**IFB-GC-FM-01-21
GWS Courthouse Elevator Addition**

Addendum #2 – Q & A Document

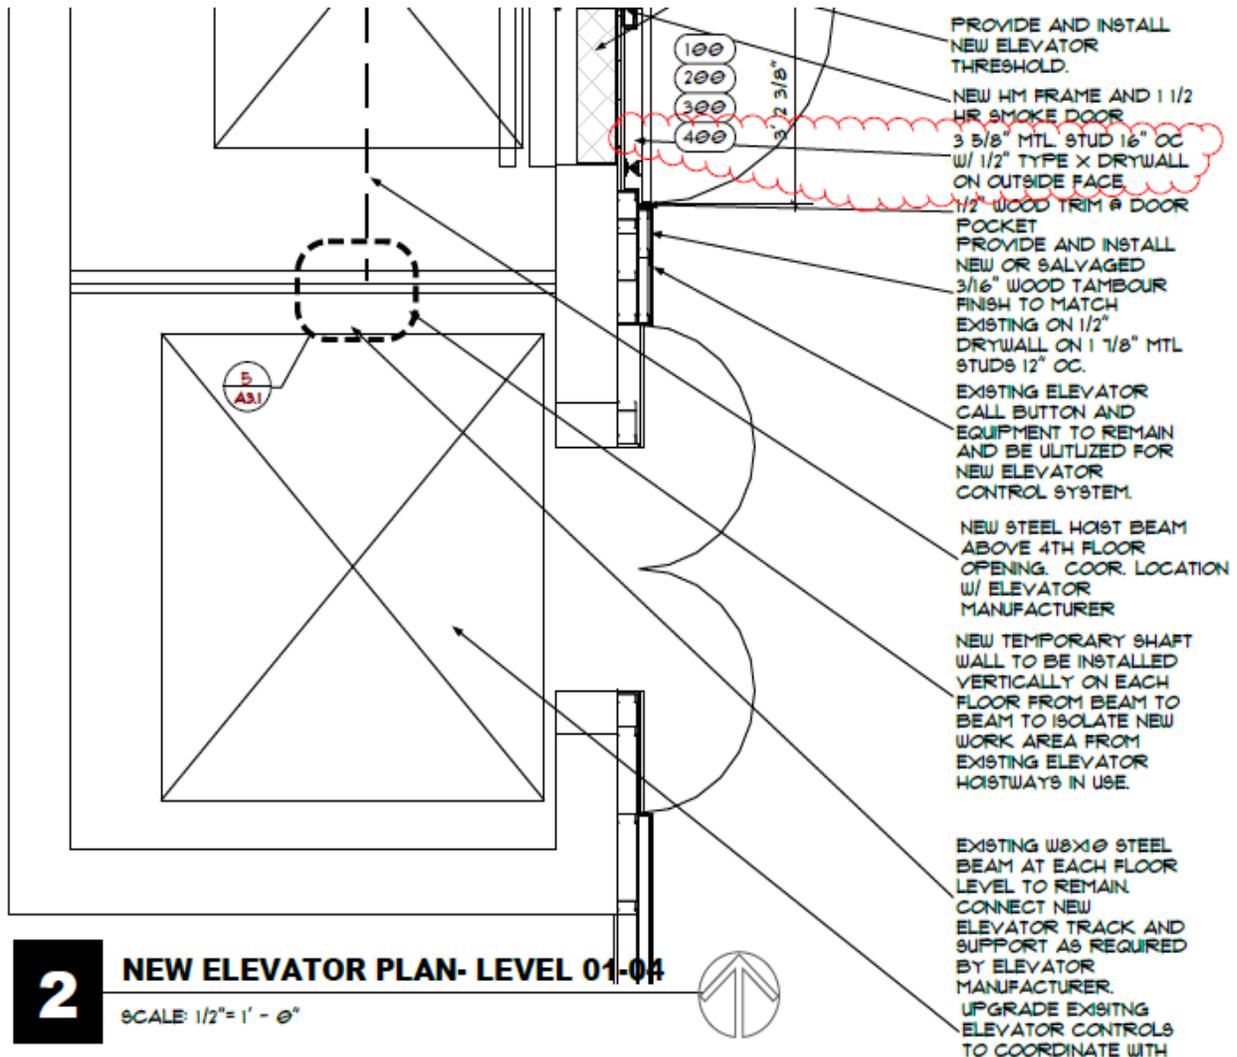
Q17: The detail on sheet A3.1 (see below) has a 3 5/8" Mtl. Stud wall being built on the hall side of the shaft. It appears that this will interfere with the door operation and is redundant to the finishes shown in details 4 and 5. Is this wall required? Detail 1 on the same sheet shows the same thing.

A17: This wall is required to attach the new HM doorframe and to provide space for the magnetic door holder. See detail 3 and 4 / A3.1.
